SUBDIVISION COMMITTEE  
METROPOLITAN AREA PLANNING COMMISSION

STAFF REPORT  
(Preliminary Plat)

CASE NUMBER: S/D 91-9 - TANNENBAUM ADDITION

STAFF REPORT  
(Final Plat, Preliminary Plat Approved 2/7/91)

VICINITY MAP:

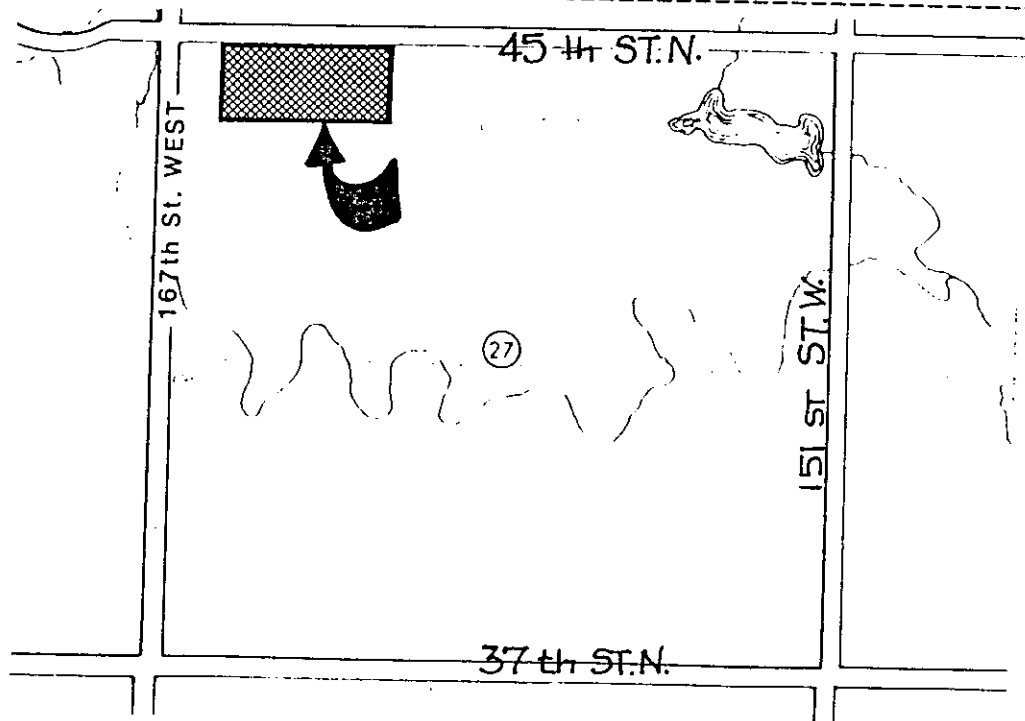
- A. Since neither municipal water nor sanitary sewer are available to serve this property, the applicant shall contact the Environmental Health Division of the Health Department to find out what tests may be necessary and what standards are to be met for approval of on-site sewerage facilities and water wells. A memorandum shall be obtained specifying approval.

- B. The applicant shall guarantee any drainage improvements required by the platting of this property.
- C. If improvements are guaranteed by petition, a notarized certificate listing the petitions shall be submitted to the Planning Department for recording.

- D. The final plat tracing shall indicate angles or bearings for the perimeter of this plat.
- E. The final plat should clearly show the amount of right-of-way being dedicated for 45th Street North.

- F. The final plat shall clearly delineate the center line for 45th Street North.
- G. Prior to, or at the time of submitting the final plat, the applicant shall submit a drainage plan to County Engineering for review and approval.

- H. The applicant should be advised that the size of the proposed site would suggest the need for a road off of 45th Street North accessing this site. In examining the quarter section map and ownership, staff would recommend 70 feet right-of-way be dedicated in between Lots 2 and 3 where there is already an existing road as well as the quarter mile line. Staff suggest a contingent dedication, provided the applicant is unable to plat any additional acres for the reduction due to right-of-way and provided County Health Department finds that acceptable (MAPC Subdivision Regulations 7-204 (T) state that the 5 acre requirement by Health Department is exclusive of street right-of-way, however, it may be modified if it is unfeasible for the subdivider to acquire additional land.)

- O. A representative from County Engineering should be prepared to comment upon needed access control along 45th Street North. Staff recommends no more than two openings.

- P. A representative of County Engineering should be prepared to comment upon acquiring a contingent dedication for right-of-way for a public road for this site. The Health Department should comment upon their requirements for site size as it relates to the potential right-of-way need.

VICINITY MAP:

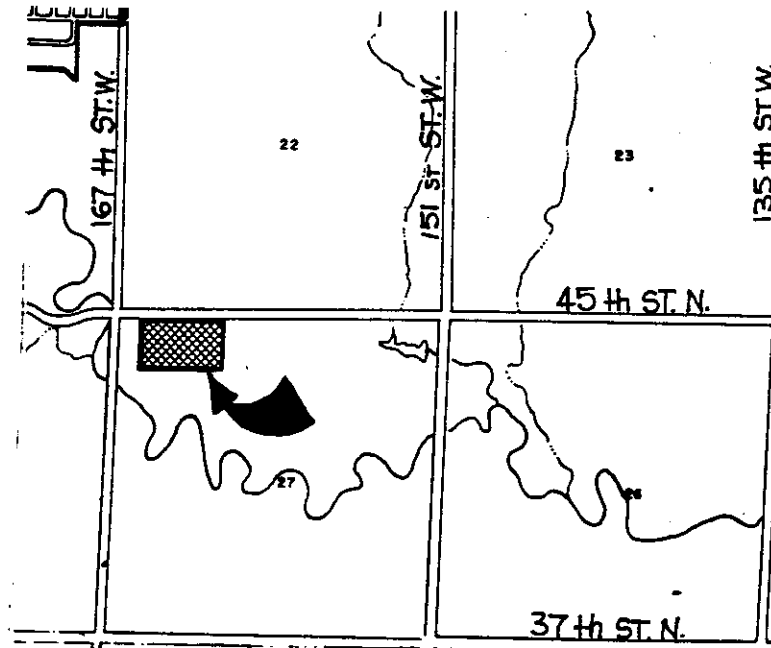
- A. Since neither municipal water nor sanitary sewer are available to serve this property, the applicant shall contact the Environmental Health Division of the Health Department to find out what tests may be necessary and what standards are to be met for approval of on-site sewerage facilities and water wells. A memorandum shall be obtained specifying approval.

- B. The applicant shall guarantee any drainage improvements required by the platting of this property.
- C. If improvements are guaranteed by petition, a notarized certificate listing the petitions shall be submitted to the Planning Department for recording.

- D. The applicant is advised that the Sedgwick County Soil Conservation Dept. is offering recommendations due to the size of the site and in order to minimize any negative impacts.

- E. On the final plat tracing, "access control except for two openings per lot" shall be shown along 45th Street North.
- F. A contingent dedication of 35 feet of half street of right-of-way along the east line of the plat is being provided for future development. This document should be submitted by separate instrument to the Planning Department for recording along with the plat. This separate instrument shall indicate the dedication is contingent upon the property to the east platting and dedicating the remaining half street of right-of-way.

- G. On the final plat tracing, the signature block for the order of the Board of County Commissioners shall be amended to show: Billy Q. McCray, Chairman; Betsy Gwin, Chairman Pro-tem; Mark F. Schroeder, Bernard A. Hentzen, and Paul W. Hancock.

- J. The applicant's engineer is advised that the Register of Deeds is requiring the name(s) of the notary public, who acknowledges the signatures on this plat, to be printed beneath the notary's signature.
- K. Perimeter closure computations shall be submitted with the final plat tracing. Section 5-101(c).
- L. Recording of the plat within 30 days after approval by the City Council.
